Interactive comment on “Seasonal stratification and property distributions in a tropical estuary (Cochin estuary, west coast, India)” by A. Shivaprasad et al.

A. Shivaprasad et al.

Fig. 1. Spatial variation in the potential energy anomaly (The months are characterised by south-west monsoon (July-August), north-east monsoon (November) and dry period (March))

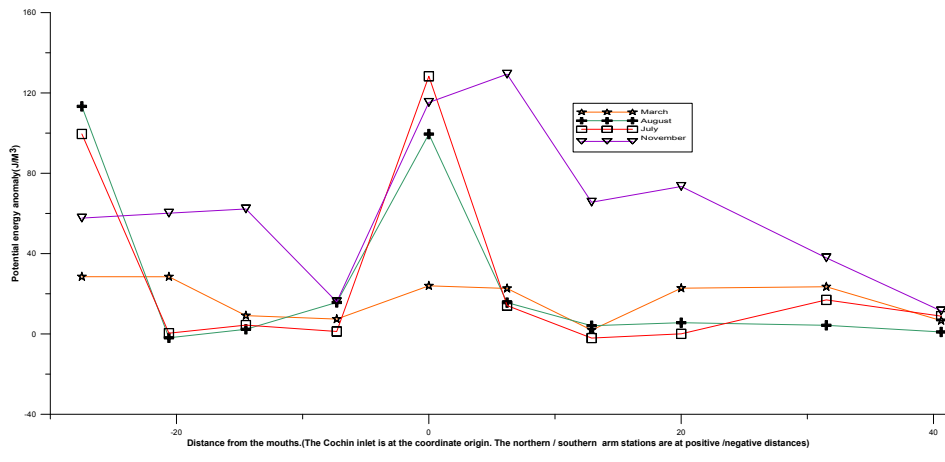
Comment (2) Potential energy anomaly computed for a single fixed station is not going to represent the whole estuary when figures of longitudinal section of salinities depict large spatial variations in stratification. This has to be explained.

Comment (3) The stability factor needs to be computed for all stations to represent seasonal stratification.

REPLY: In accordance with the reviewer's suggestion, we have computed PEA from the density profiles of spring phase of intrusion survey (Synoptic observation -section 2.2) for the months July 2008, August 2008, November 2008 and March 2009 which are shown in (Figure 9 -Please also note the figures to this comment). These months are characterised by south-west monsoon, north-east monsoon and dry period, respectively. The results obtained were in strong agreement with our longitudinal synoptic observations of salinity which are incorporated in the revised manuscript. The spatial variations in PEA plainly depict the changes in stratification due to bathymetry and seasonal river discharge. During July, the PEA also reached the maximum value of 128.3 J/M³ near the inlets whereas all the other stations remained well mixed (PEA~0). In August also, similar character was observed with high values of PEA 113.2 J/M³ near the inlets. Then river discharge was reduced to 3.34% in November. This resulted in the longitudinal dispersion of the salinity field and the PEA in the upstream of the system increased to 68.2 J/M³. Later during the dry period (March), discharge was only 1.4%. Therefore, the tidal actions dominated in the system which subsequently turned to well mixed and the average energy required to mix the water column in the estuary was 33.8 J/M³.

REPLY: The stability factor is computed for all stations to represent seasonal stratification. The spatial variation in the potential energy anomaly is shown in Fig. 9. The potential energy anomaly (PEA) increases with increasing river discharges, specifically to the inlet regions in the south-west monsoon and north-east monsoon periods.

Fig. 2. Monthly river discharge, surface salinity, surface chlorophyll a starting from June 2008 and finishing May 2009.

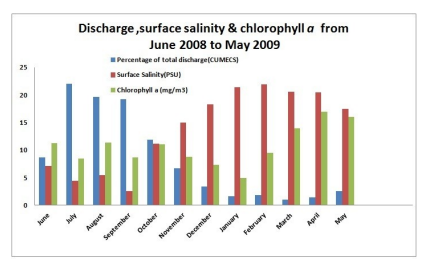
Technical comment(3) In Figure 2b: The scale of X-axis starts from January to December but you have written in the legend Jun 2008 to May 2009. Please start the scale of X-axis from Jun 2008.

REPLY: Figure 2b (Please also note the figures to this comment) as rearranged as follows; it has been rectified in revised manuscript
